Issue detail

Created on	Nov 5, 2026, 9:41 PM PST
Created by	**Gracie Wallace** (F26-CEE120A_220A)
Total items	10
Sorted by	ID (Ascending)
Filtered by	Created on (Oct 29, 2026 - Nov 5, 2026)

#1: Cantilever wall too close to stair

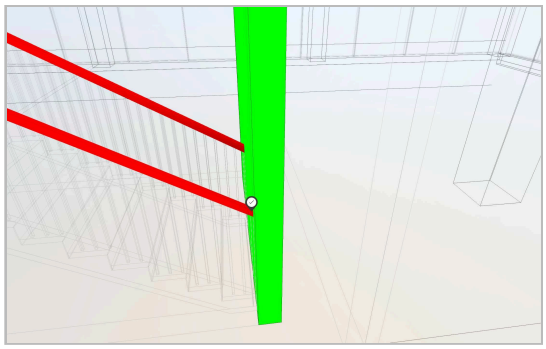
Status	**Open**
Type	CL Coordination > Clash
ID	#1
Description	11 total clashes: 1 clash between Top Rail Type [390264] in Wallace - Building Module 6 ARCH.rvt - 3D - ARCHITECTURE COORDINATION and Wallace-Building Module 6 STRUC.rvt - 3D - STRUCTURAL COORDINATION 1 clash between Top Rail Type [390276] in Wallace - Building Module 6 ARCH.rvt - 3D - ARCHITECTURE COORDINATION and Wallace-Building Module 6 STRUC.rvt - 3D - STRUCTURAL COORDINATION 1 clash between Top Rail Type [390358] in Wallace - Building Module 6 ARCH.rvt - 3D - ARCHITECTURE COORDINATION and Wallace-Building Module 6 STRUC.rvt - 3D - STRUCTURAL COORDINATION 1 clash between Top Rail Type [390466] in Wallace - Building Module 6 ARCH.rvt - 3D - ARCHITECTURE COORDINATION and Wallace-Building Module 6 STRUC.rvt - 3D - STRUCTURAL COORDINATION 1 clash between Top Rail Type [390574] in Wallace - Building Module 6 ARCH.rvt - 3D - ARCHITECTURE COORDINATION and Wallace-Building Module 6 STRUC.rvt - 3D - STRUCTURAL COORDINATION 1 clash between Top Rail Type [390895] in Wallace - B...

#2: Cantilever walls too close to stairs

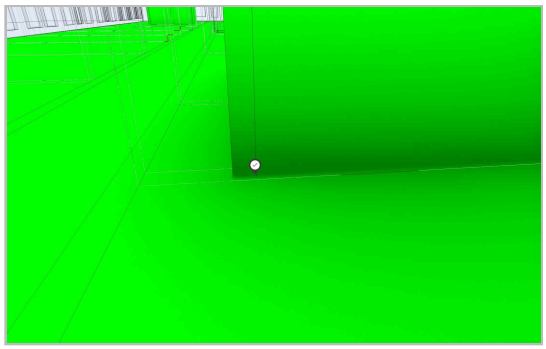
Description	59 total clashes: 8 clashes between Assembled Stair [390215] in Wallace - Building Module 6 ARCH.rvt - 3D - ARCHITECTURE COORDINATION and Wallace-Building Module 6 STRUC.rvt - 3D - STRUCTURAL COORDINATION 5 clashes between Assembled Stair [390323] in Wallace - Building Module 6 ARCH.rvt - 3D - ARCHITECTURE COORDINATION and Wallace-Building Module 6 STRUC.rvt - 3D - STRUCTURAL COORDINATION 5 clashes between Assembled Stair [390431] in Wallace - Building Module 6 ARCH.rvt - 3D - ARCHITECTURE COORDINATION and Wallace-Building Module 6 STRUC.rvt - 3D - STRUCTURAL COORDINATION 5 clashes between Assembled Stair [390539] in Wallace - Building Module 6 ARCH.rvt - 3D - ARCHITECTURE COORDINATION and Wallace-Building Module 6 STRUC.rvt - 3D - STRUCTURAL COORDINATION 8 clashes between Assembled Stair [390834] in Wallace - Building Module 6 ARCH.rvt - 3D - ARCHITECTURE COORDINATION and Wallace-Building Module 6 STRUC.rvt - 3D - STRUCTURAL COORDINATION 5 clashes between Assembled Stair...

#3: Elevator shaft interferes with facade

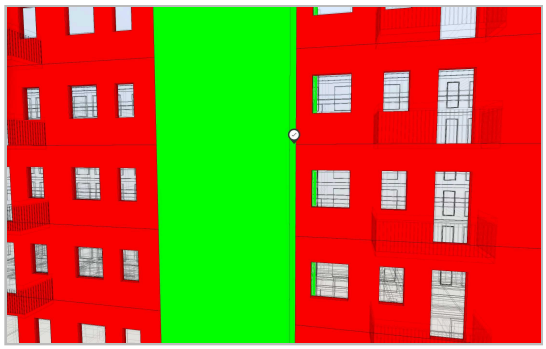
Status	**Open**
Type	CL Coordination > Clash
ID	#3
Description	12 total clashes: 2 clashes between Basic Wall [376860] in Wallace - Building Module 6 ARCH.rvt - 3D - ARCHITECTURE COORDINATION and Wallace-Building Module 6 STRUC.rvt - 3D - STRUCTURAL COORDINATION 2 clashes between Basic Wall [376864] in Wallace - Building Module 6 ARCH.rvt - 3D - ARCHITECTURE COORDINATION and Wallace-Building Module 6 STRUC.rvt - 3D - STRUCTURAL COORDINATION 2 clashes between Basic Wall [376869] in Wallace - Building Module 6 ARCH.rvt - 3D - ARCHITECTURE COORDINATION and Wallace-Building Module 6 STRUC.rvt - 3D - STRUCTURAL COORDINATION 2 clashes between Basic Wall [376872] in Wallace - Building Module 6 ARCH.rvt - 3D - ARCHITECTURE COORDINATION and Wallace-Building Module 6 STRUC.rvt - 3D - STRUCTURAL COORDINATION 2 clashes between Basic Wall [376876] in Wallace - Building Module 6 ARCH.rvt - 3D - ARCHITECTURE COORDINATION and Wallace-Building Module 6 STRUC.rvt - 3D - STRUCTURAL COORDINATION 2 clashes between Basic Wall [376882] in Wallace - Buildin...

#4: Interior walls intersecting shaft structural walls

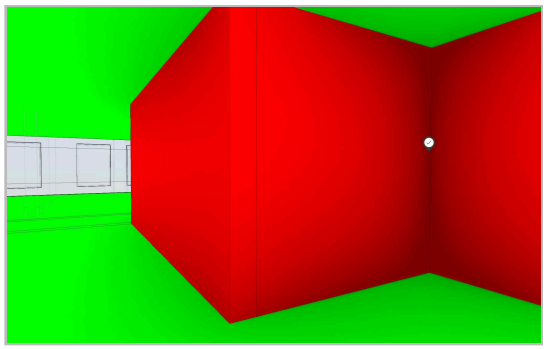
Status	**Open**
Type	CL Coordination > Clash
ID	#4
Description	85 total clashes: 4 clashes between Basic Wall [376890] in Wallace - Building Module 6 ARCH.rvt - 3D - ARCHITECTURE COORDINATION and Wallace-Building Module 6 STRUC.rvt - 3D - STRUCTURAL COORDINATION 3 clashes between Basic Wall [376891] in Wallace - Building Module 6 ARCH.rvt - 3D - ARCHITECTURE COORDINATION and Wallace-Building Module 6 STRUC.rvt - 3D - STRUCTURAL COORDINATION 4 clashes between Basic Wall [376892] in Wallace - Building Module 6 ARCH.rvt - 3D - ARCHITECTURE COORDINATION and Wallace-Building Module 6 STRUC.rvt - 3D - STRUCTURAL COORDINATION 4 clashes between Basic Wall [376893] in Wallace - Building Module 6 ARCH.rvt - 3D - ARCHITECTURE COORDINATION and Wallace-Building Module 6 STRUC.rvt - 3D - STRUCTURAL COORDINATION 2 clashes between Basic Wall [376894] in Wallace - Building Module 6 ARCH.rvt - 3D - ARCHITECTURE COORDINATION and Wallace-Building Module 6 STRUC.rvt - 3D - STRUCTURAL COORDINATION 4 clashes between Basic Wall [376895] in Wallace - Buildin...

#5: Interior walls intersecting shaft structural walls

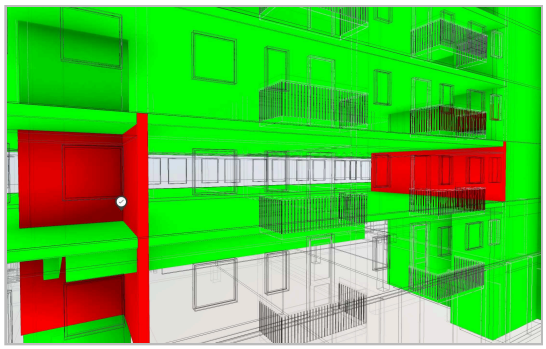
Status	**Open**
Type	CL Coordination > Clash
ID	#5
Description	83 total clashes: 2 clashes between Basic Wall [376954] in Wallace - Building Module 6 ARCH.rvt - 3D - ARCHITECTURE COORDINATION and Wallace-Building Module 6 STRUC.rvt - 3D - STRUCTURAL COORDINATION 4 clashes between Basic Wall [376955] in Wallace - Building Module 6 ARCH.rvt - 3D - ARCHITECTURE COORDINATION and Wallace-Building Module 6 STRUC.rvt - 3D - STRUCTURAL COORDINATION 4 clashes between Basic Wall [376956] in Wallace - Building Module 6 ARCH.rvt - 3D - ARCHITECTURE COORDINATION and Wallace-Building Module 6 STRUC.rvt - 3D - STRUCTURAL COORDINATION 4 clashes between Basic Wall [376957] in Wallace - Building Module 6 ARCH.rvt - 3D - ARCHITECTURE COORDINATION and Wallace-Building Module 6 STRUC.rvt - 3D - STRUCTURAL COORDINATION 2 clashes between Basic Wall [376958] in Wallace - Building Module 6 ARCH.rvt - 3D - ARCHITECTURE COORDINATION and Wallace-Building Module 6 STRUC.rvt - 3D - STRUCTURAL COORDINATION 4 clashes between Basic Wall [376963] in Wallace - Buildin...

#6: Interior walls intersecting shaft structural walls

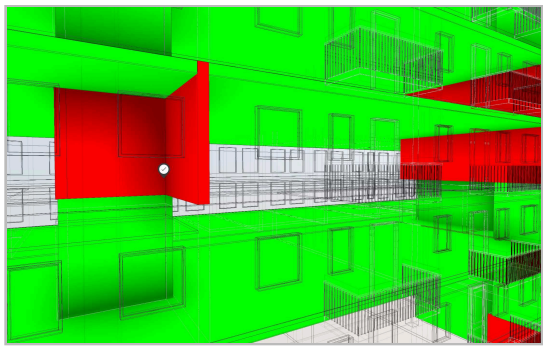
Status	**Open**
Type	CL Coordination > Clash
ID	#6
Description	64 total clashes: 4 clashes between Basic Wall [377002] in Wallace - Building Module 6 ARCH.rvt - 3D - ARCHITECTURE COORDINATION and Wallace-Building Module 6 STRUC.rvt - 3D - STRUCTURAL COORDINATION 3 clashes between Basic Wall [377003] in Wallace - Building Module 6 ARCH.rvt - 3D - ARCHITECTURE COORDINATION and Wallace-Building Module 6 STRUC.rvt - 3D - STRUCTURAL COORDINATION 4 clashes between Basic Wall [377007] in Wallace - Building Module 6 ARCH.rvt - 3D - ARCHITECTURE COORDINATION and Wallace-Building Module 6 STRUC.rvt - 3D - STRUCTURAL COORDINATION 3 clashes between Basic Wall [377008] in Wallace - Building Module 6 ARCH.rvt - 3D - ARCHITECTURE COORDINATION and Wallace-Building Module 6 STRUC.rvt - 3D - STRUCTURAL COORDINATION 3 clashes between Basic Wall [377009] in Wallace - Building Module 6 ARCH.rvt - 3D - ARCHITECTURE COORDINATION and Wallace-Building Module 6 STRUC.rvt - 3D - STRUCTURAL COORDINATION 3 clashes between Basic Wall [377013] in Wallace - Buildin...

#7: Interior walls intersecting shaft structural walls

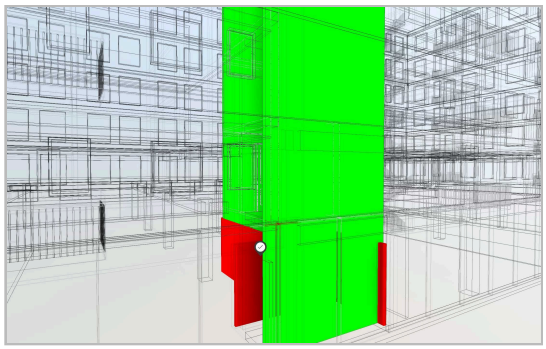
Status	**Open**
Type	CL Coordination > Clash
ID	#7
Description	6 total clashes: 1 clash between Basic Wall [579900] in Wallace - Building Module 6 ARCH.rvt - 3D - ARCHITECTURE COORDINATION and Wallace-Building Module 6 STRUC.rvt - 3D - STRUCTURAL COORDINATION 2 clashes between Basic Wall [579954] in Wallace - Building Module 6 ARCH.rvt - 3D - ARCHITECTURE COORDINATION and Wallace-Building Module 6 STRUC.rvt - 3D - STRUCTURAL COORDINATION 3 clashes between Basic Wall [580029] in Wallace - Building Module 6 ARCH.rvt - 3D - ARCHITECTURE COORDINATION and Wallace-Building Module 6 STRUC.rvt - 3D - STRUCTURAL COORDINATION
Assigned to	—
Created by	Gracie Wallace (F26-CEE120A_220A)
Created on	Nov 5, 2026
Location	—
Location details	—
Due date	—
Start date	—
Placement	Wallace - Building Module 6 ARCH.rvt

#8: Curtain wall needs to be adjusted for balconies and mech shaft

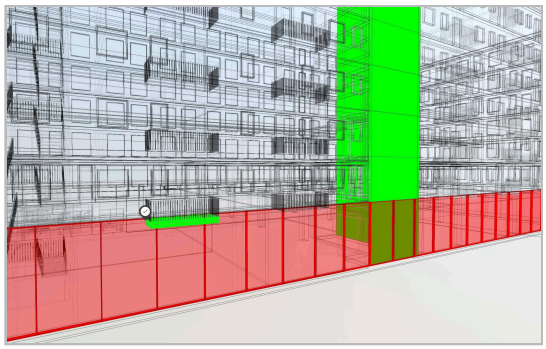
Status	Open
Type	CL Coordination > Clash
ID	#8
Description	5 total clashes: 1 clash between Curtain Wall [378048] in Wallace - Building Module 6 ARCH.rvt - 3D - ARCHITECTURE COORDINATION and Wallace-Building Module 6 STRUC.rvt - 3D - STRUCTURAL COORDINATION 4 clashes between Curtain Wall [378399] in Wallace - Building Module 6 ARCH.rvt - 3D - ARCHITECTURE COORDINATION and Wallace-Building Module 6 STRUC.rvt - 3D - STRUCTURAL COORDINATION
Assigned to	—
Created by	Gracie Wallace (F26-CEE120A_220A)
Created on	Nov 5, 2026
Location	—
Location details	—
Due date	—
Start date	—
Placement	Wallace - Building Module 6 ARCH.rvt
Root cause	—

#9: Columns go through stairs

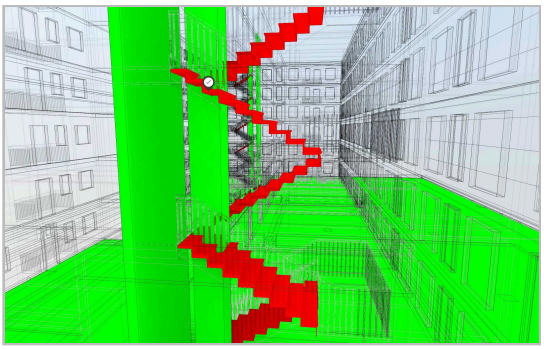
Description	19 total clashes: 1 clash between Non-Monolithic Landing [392904] in Wallace - Building Module 6 ARCH.rvt - 3D - ARCHITECTURE COORDINATION and Wallace-Building Module 6 STRUC.rvt - 3D - STRUCTURAL COORDINATION 1 clash between Non-Monolithic Run [390216] in Wallace - Building Module 6 ARCH.rvt - 3D - ARCHITECTURE COORDINATION and Wallace-Building Module 6 STRUC.rvt - 3D - STRUCTURAL COORDINATION 1 clash between Non-Monolithic Run [390245] in Wallace - Building Module 6 ARCH.rvt - 3D - ARCHITECTURE COORDINATION and Wallace-Building Module 6 STRUC.rvt - 3D - STRUCTURAL COORDINATION 1 clash between Non-Monolithic Run [390324] in Wallace - Building Module 6 ARCH.rvt - 3D - ARCHITECTURE COORDINATION and Wallace-Building Module 6 STRUC.rvt - 3D - STRUCTURAL COORDINATION 1 clash between Non-Monolithic Run [390339] in Wallace - Building Module 6 ARCH.rvt - 3D - ARCHITECTURE COORDINATION and Wallace-Building Module 6 STRUC.rvt - 3D - STRUCTURAL COORDINATION 1 clash between Non-Mono...

#10: Stairs need some more space - walls overlap with railings and stringers

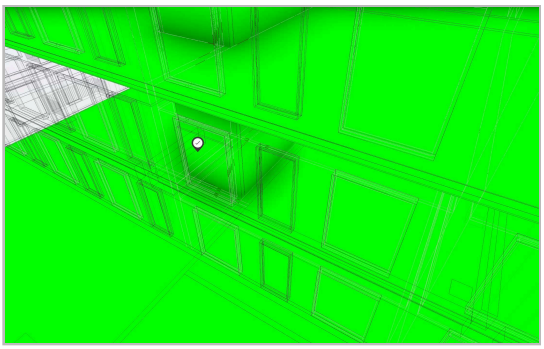
Status	**Open**
Type	CL Coordination > Clash
ID	#10
Description	79 total clashes: 1 clash between Railing [390253] in Wallace - Building Module 6 ARCH.rvt - 3D - ARCHITECTURE COORDINATION and Wallace-Building Module 6 STRUC.rvt - 3D - STRUCTURAL COORDINATION 1 clash between Railing [390872] in Wallace - Building Module 6 ARCH.rvt - 3D - ARCHITECTURE COORDINATION and Wallace-Building Module 6 STRUC.rvt - 3D - STRUCTURAL COORDINATION 1 clash between Railing [392571] in Wallace - Building Module 6 ARCH.rvt - 3D - ARCHITECTURE COORDINATION and Wallace-Building Module 6 STRUC.rvt - 3D - STRUCTURAL COORDINATION 1 clash between Railing [392575] in Wallace - Building Module 6 ARCH.rvt - 3D - ARCHITECTURE COORDINATION and Wallace-Building Module 6 STRUC.rvt - 3D - STRUCTURAL COORDINATION 1 clash between Railing [392913] in Wallace - Building Module 6 ARCH.rvt - 3D - ARCHITECTURE COORDINATION and Wallace-Building Module 6 STRUC.rvt - 3D - STRUCTURAL COORDINATION 1 clash between Railing [392917] in Wallace - Building Module 6 ARCH.rvt - 3D - ARC...
